6140 SOUTHMOOR DRIVE

SITE DEVELOPMENT PLAN

THE PURPOSE OF THIS SITE DEVELOPMENT PLAN AMENDMENT IS TO CONSTRUCT A METAL BUILDING AND PAVED PARKING.

COVER SHEET
SITE DEVELOPMENT PLAN
6140 SOUTHMOOR DRIVE
FOUNTAIN, COLORADO

A1.0A	J C D E S I G N A R Y M I N I M U M	JC Design, LLC. 20740 Warriors Path Dr. PEYTON, CO 80831 Copyright © 2026 JEREMY CLEVELAND, JC DESIGN, LLC.	REVISION	DATE: MARCH 10, 2026 ADDRESS: 6140 SOUTHMOOR DRIVE FOUNTAIN, CO 80817 PROJECT: SAFE GUARD TRAFFIC CONTROL DRAWN BY: JEREMY CLEVELAND
			BY

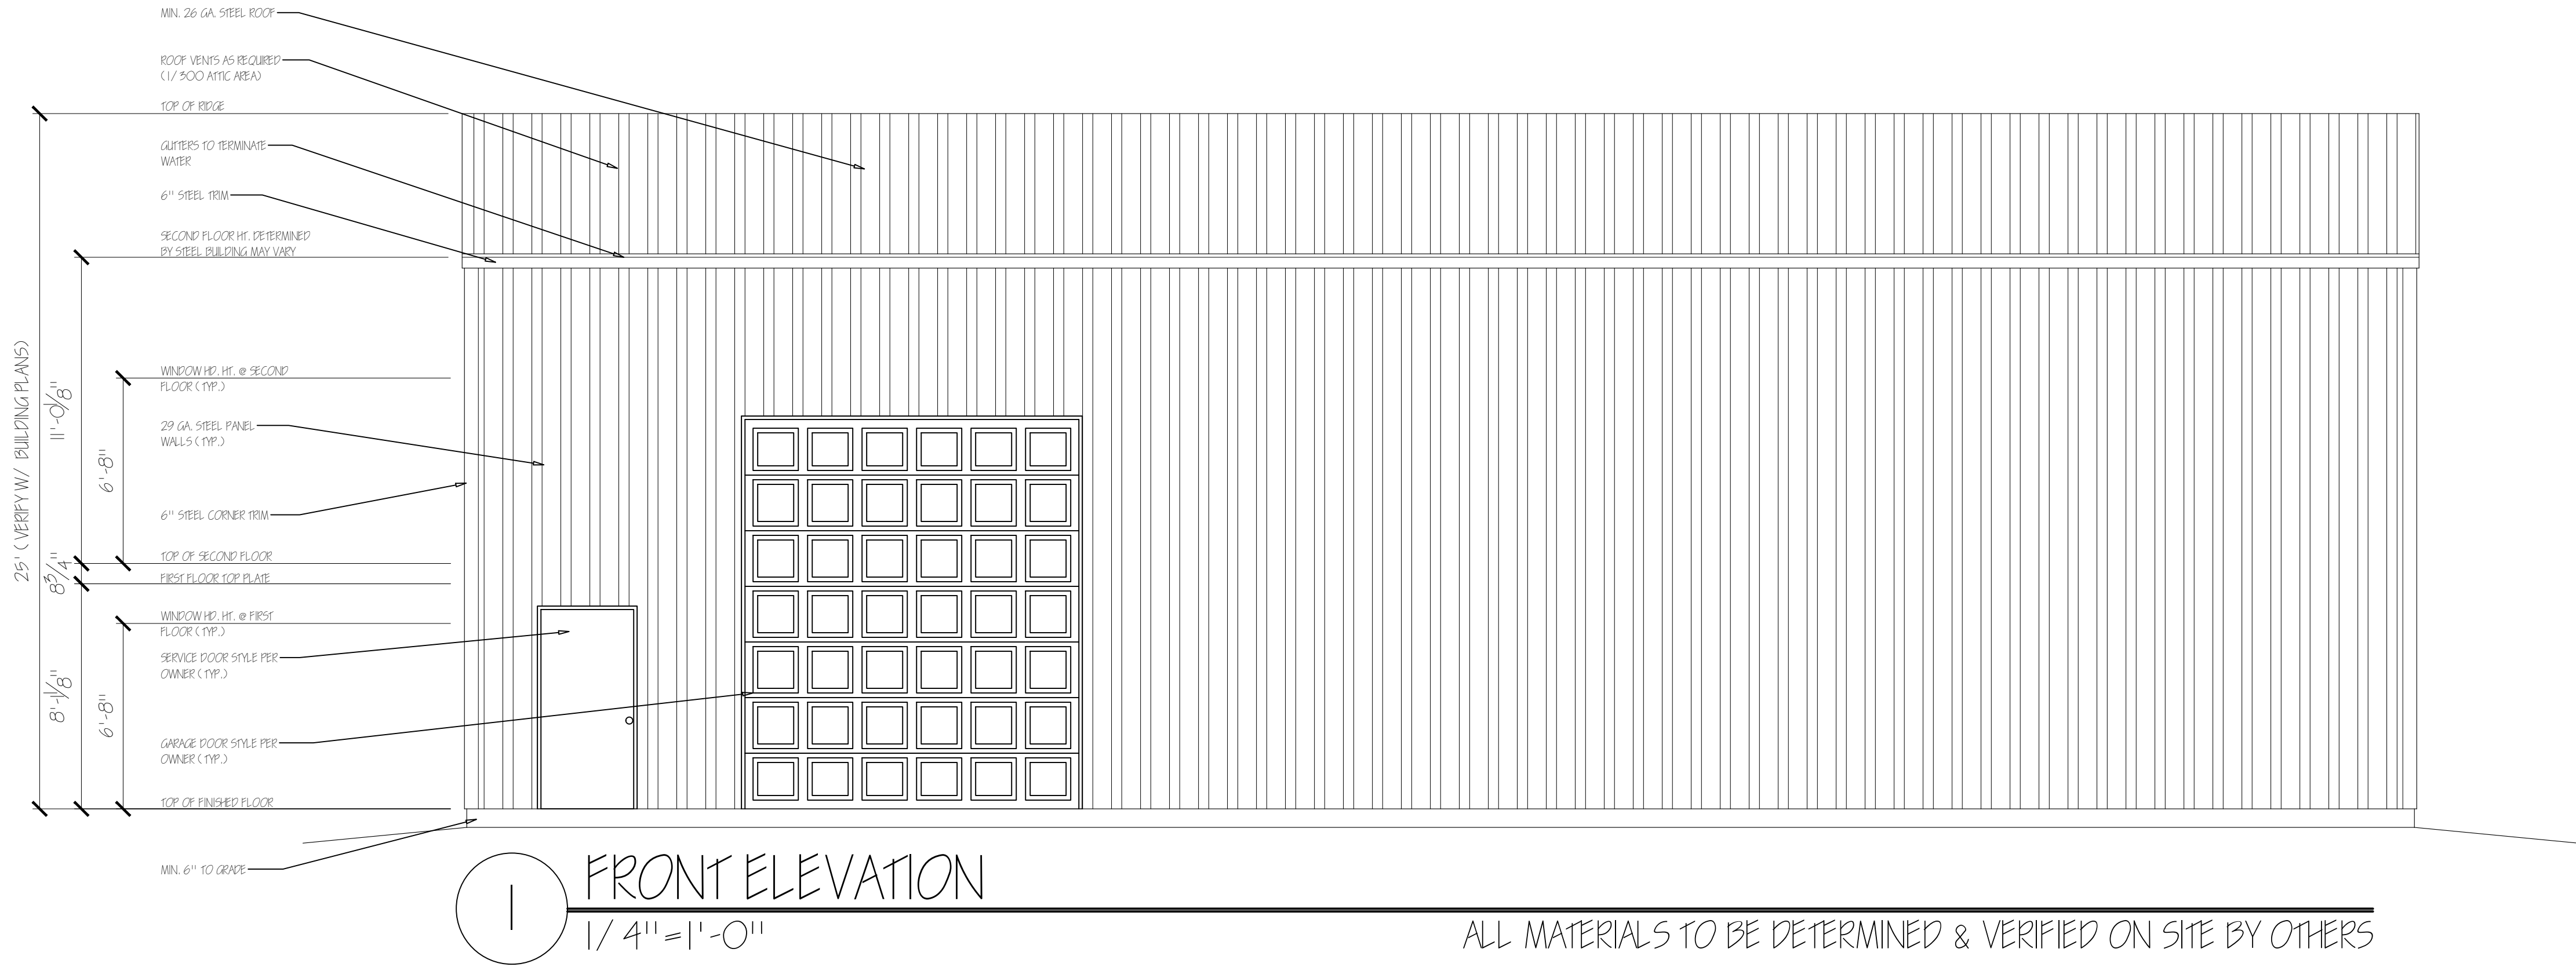
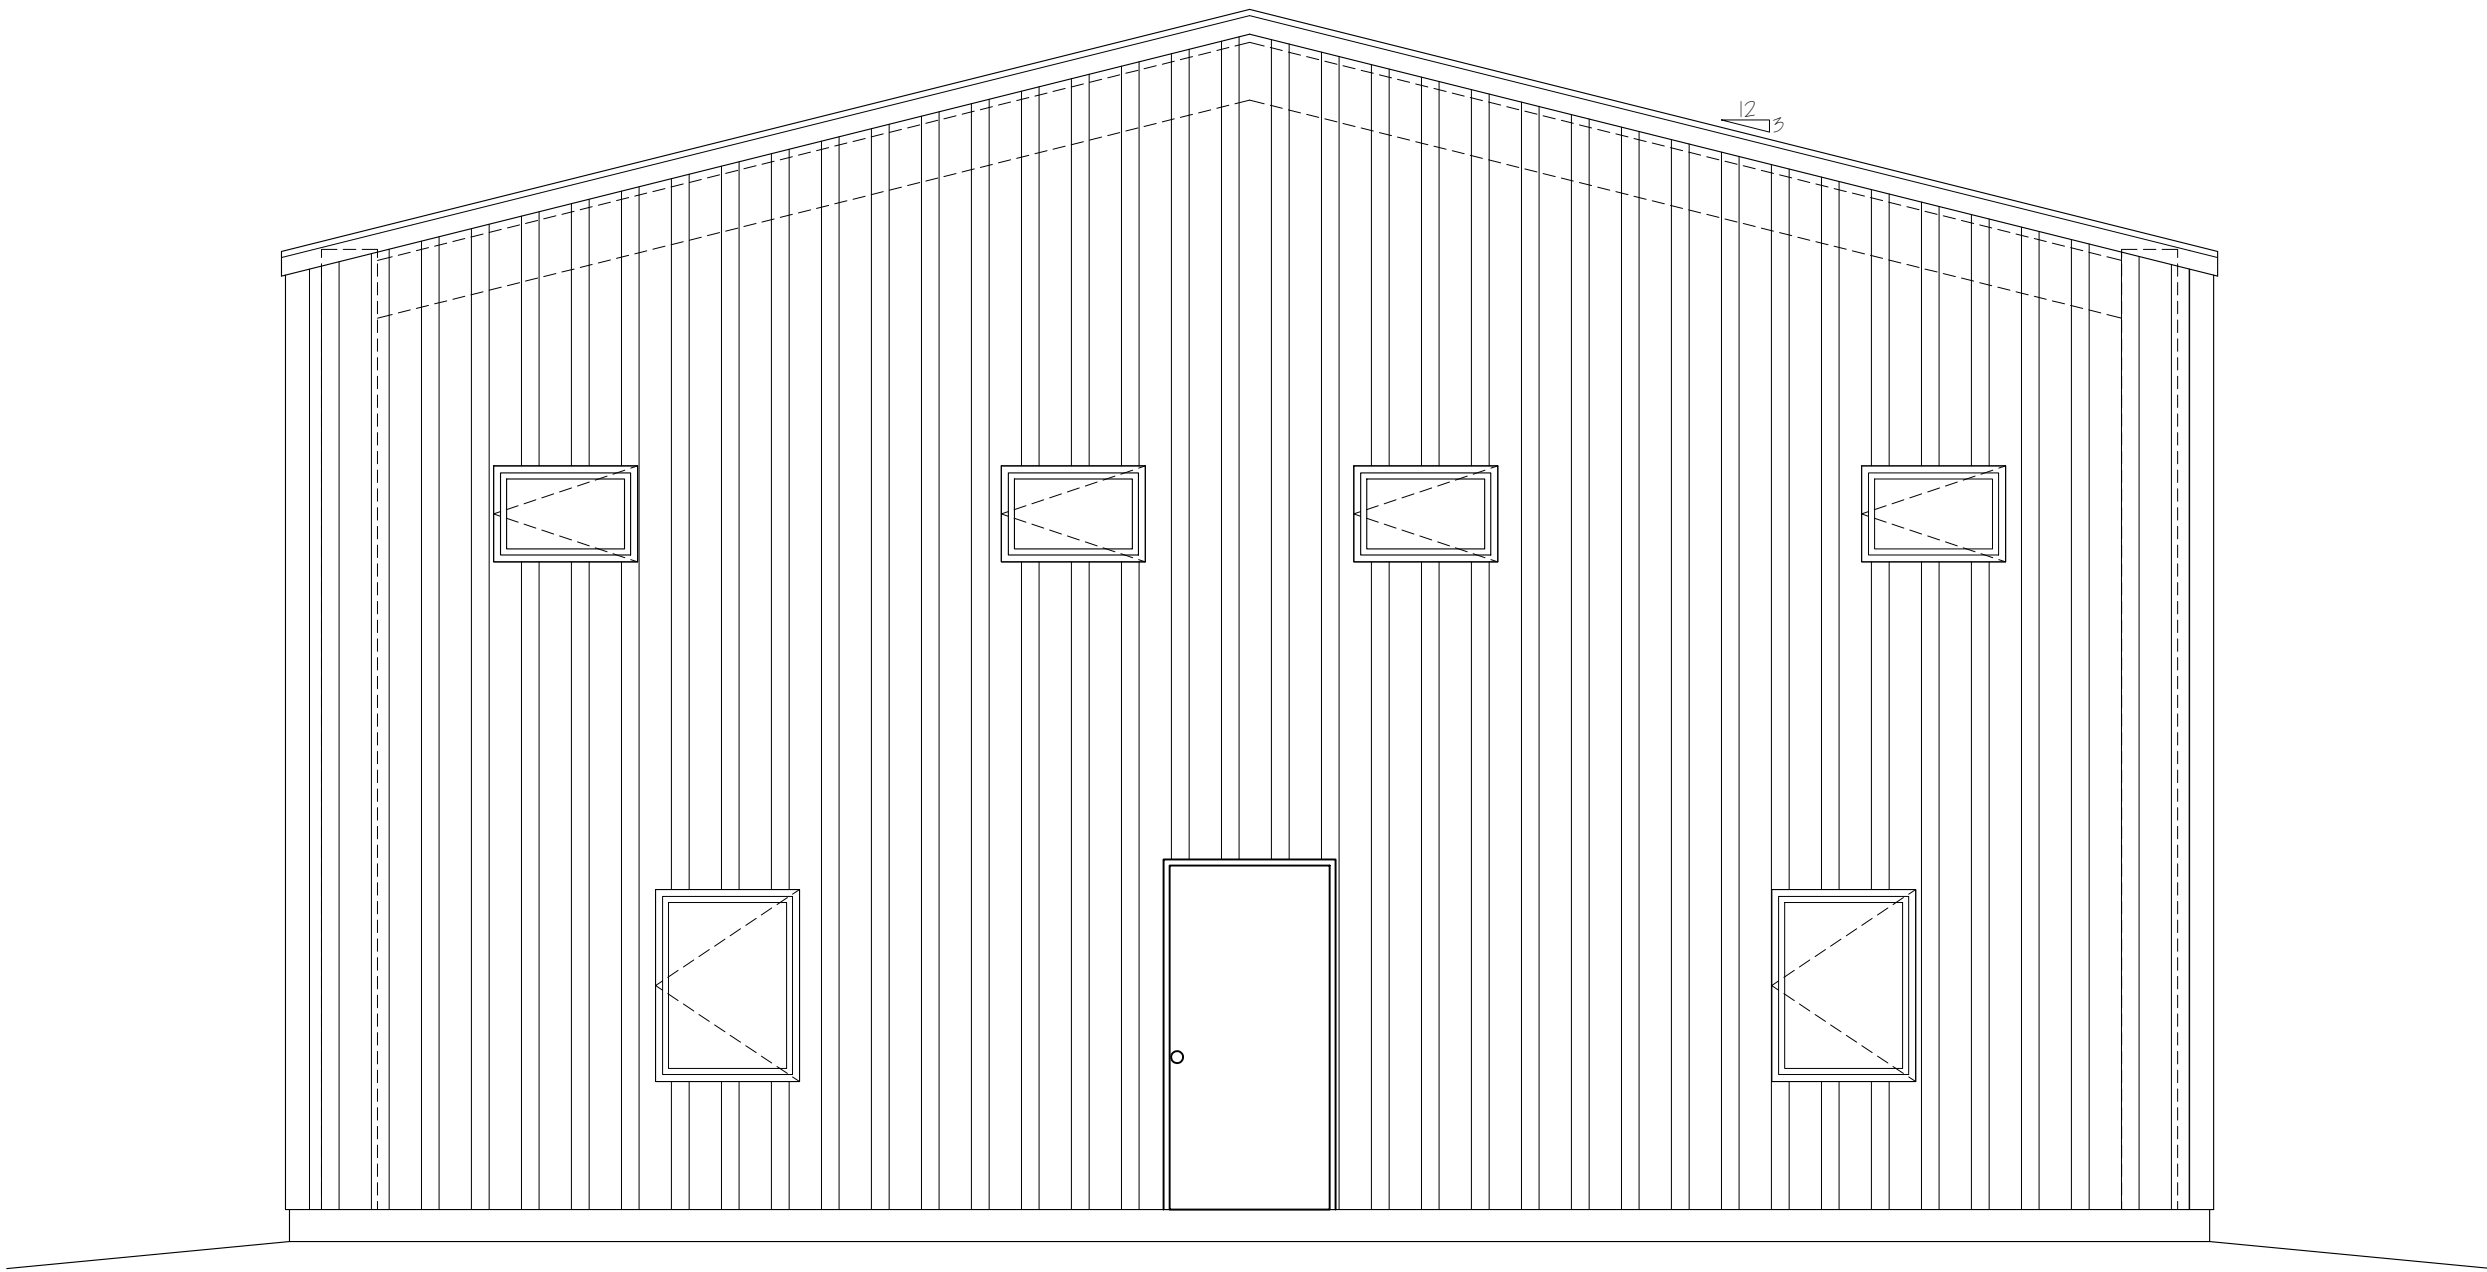
If gas service is proposed
Gas meter locations on plan view and building elevations must be shown and labeled.
Add note " Gas meters must be a minimum of 3-feet from doors, operable windows, or any vents or openings in walls."
